As a part of reviewing the cost of obtaining and placing the riprap material from the off-site source, we also have taken the opportunity to update the equipment and labor rates used in the cost estimate calculations. In addition, we have revised the cover design to exclude the one-foot thick clay layer on the side slopes of the reclaimed area.

The reclamation cover design has been modified to exclude the use of the one foot thick clay layer on the side slopes of the reclaimed area. The clay layer is designed to reduce radon emanation from the stored tailing sands and therefore serves no purpose over the side slopes of the reclaimed area. The effect of this modification is to reduce the required volume of compacted clay by 28,410 yd³. The volume is replaced by a like amount of random fill, for a reduction in material and placement costs from \$7.98/yd³ for the clay to \$0.43/yd³ for the random fill. The overall reduction in cost is \$7.55/yd³ (\$214,500). The design modification is detailed on the attached revisions (Attachment 5) to Figures A-5.1-1, A-5.1-2 and A-5.1-3.

REV.	DATE	BY	REVISIONS	International Uranium (USA) Corporation White Mesa Mill	
1				FIGURE A-5.1-2 Reclamatio

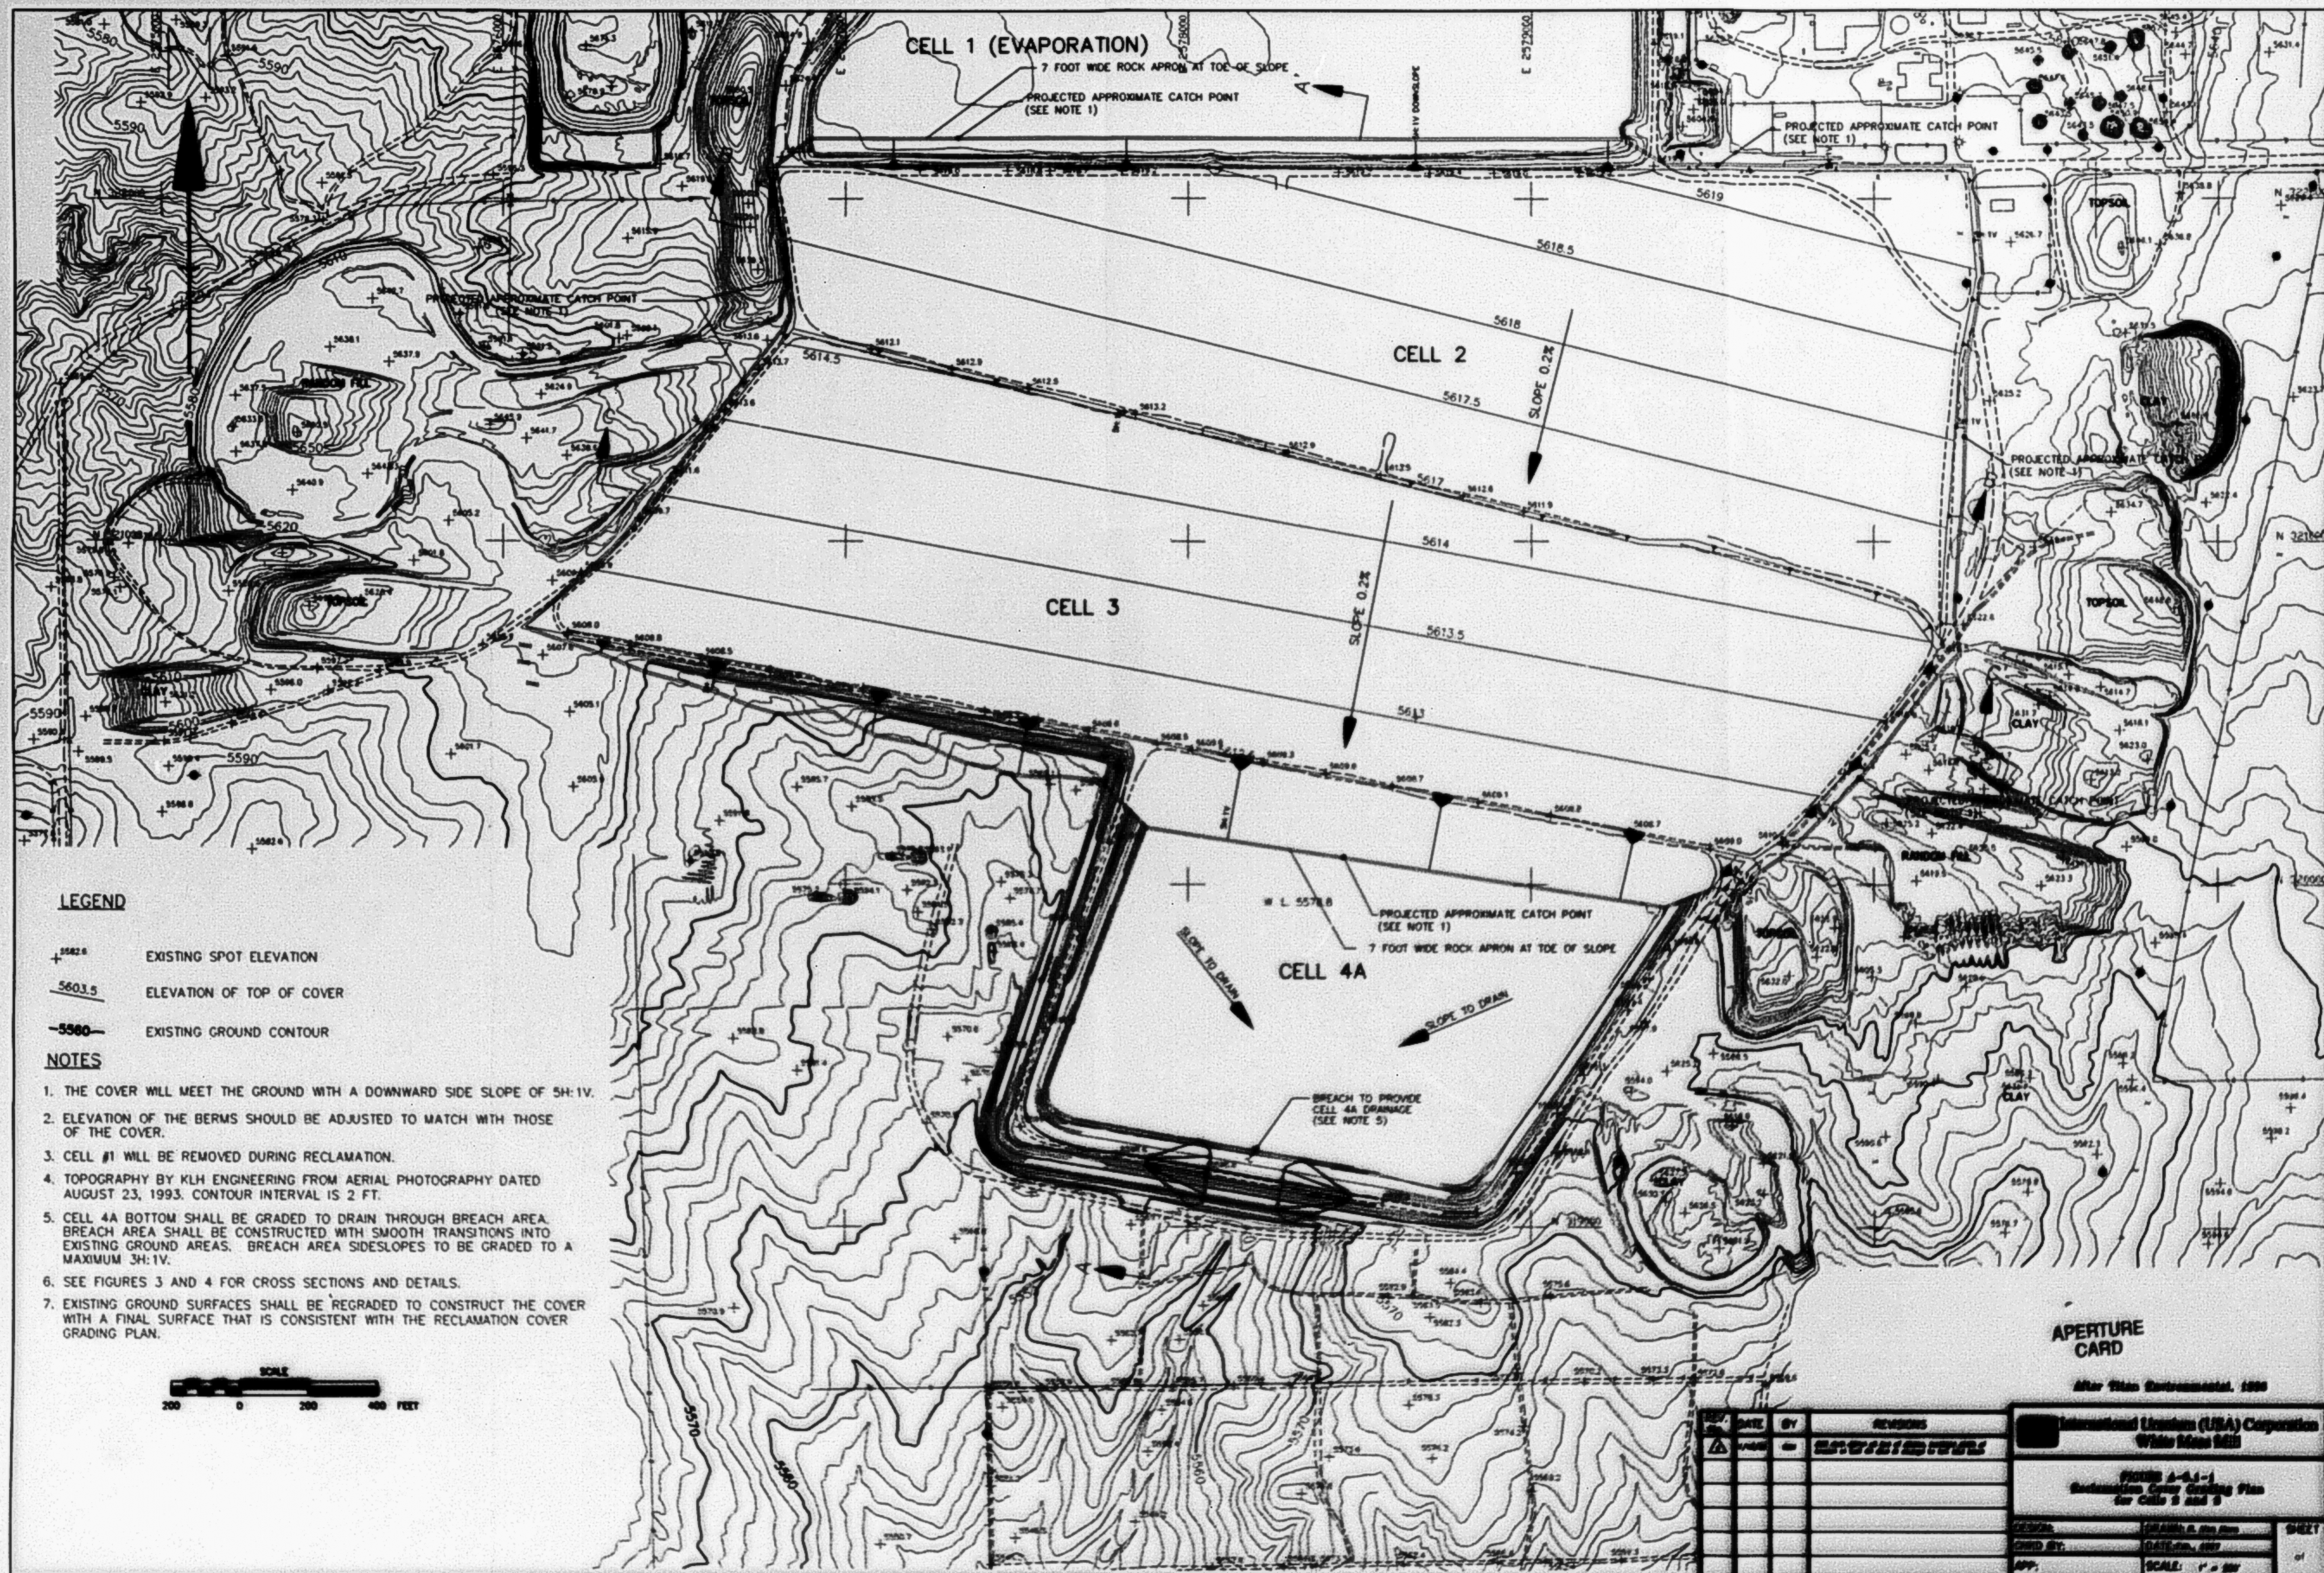
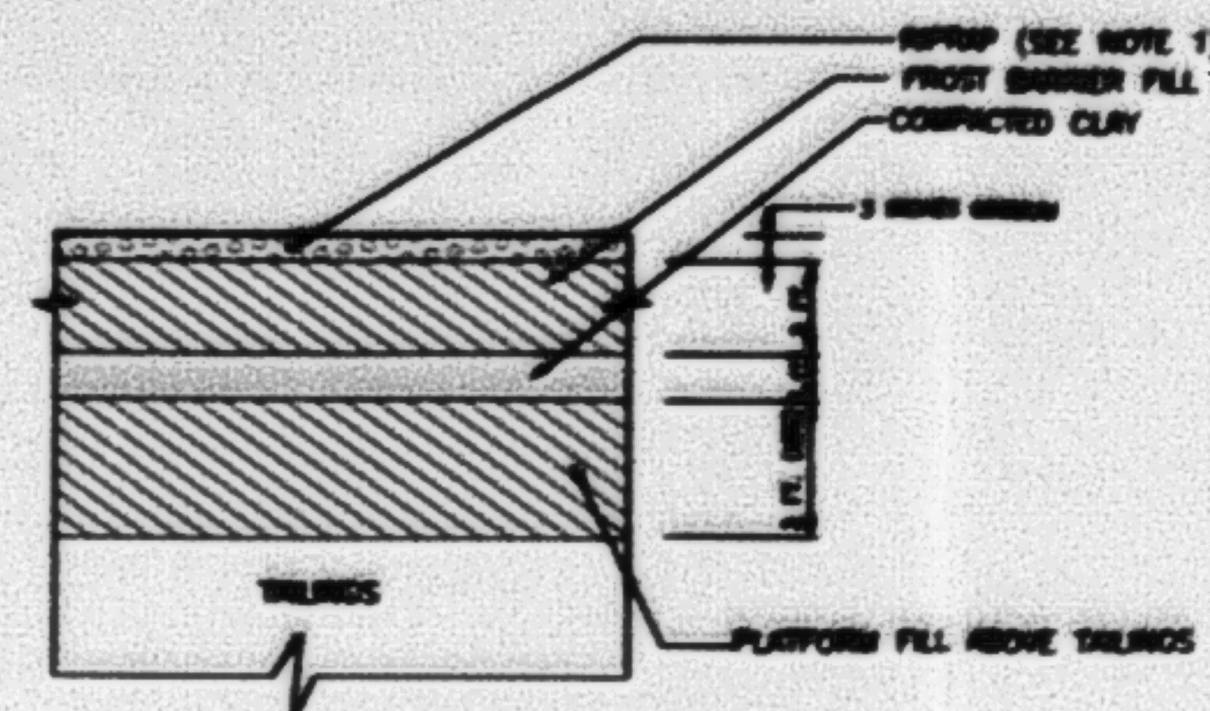
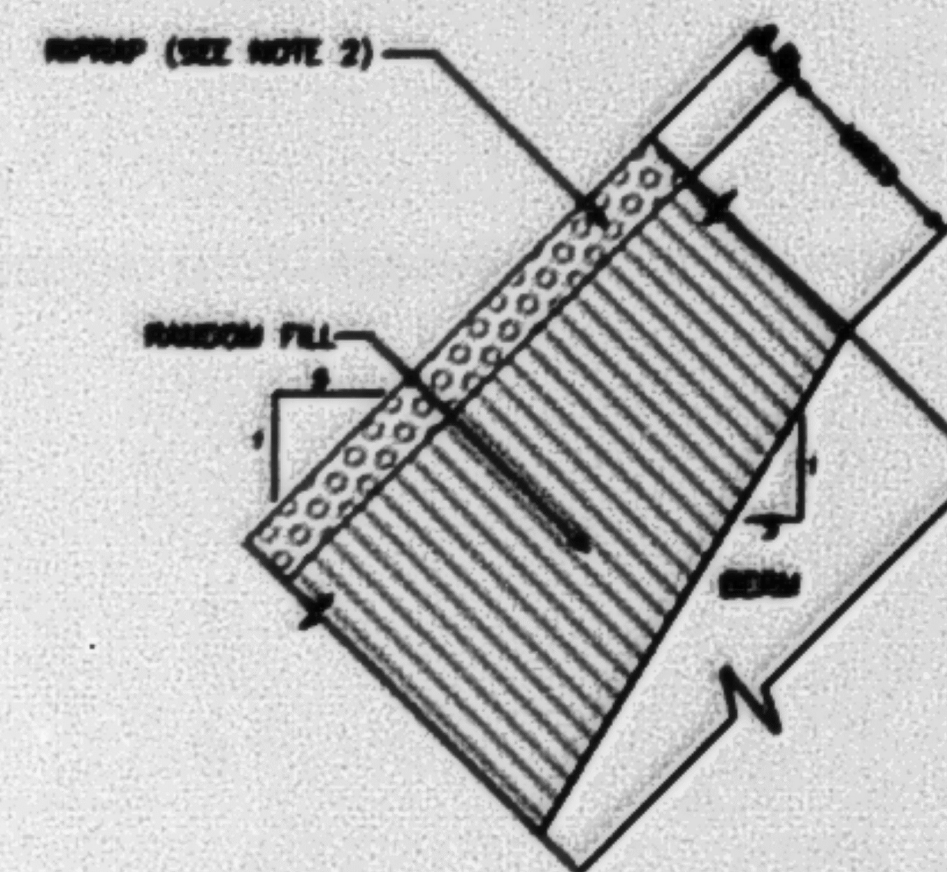
Note 5 Cost saving as a result of eliminating the 1 foot clay layer on the exterior side slopes. Ongoing field tests show that radon emanation rates from side slopes fall far below max allowed levels without the need of the clay layer

DETAIL 2: COVER DETAIL FOR SIDE SLOPES
(NOT TO SCALE)
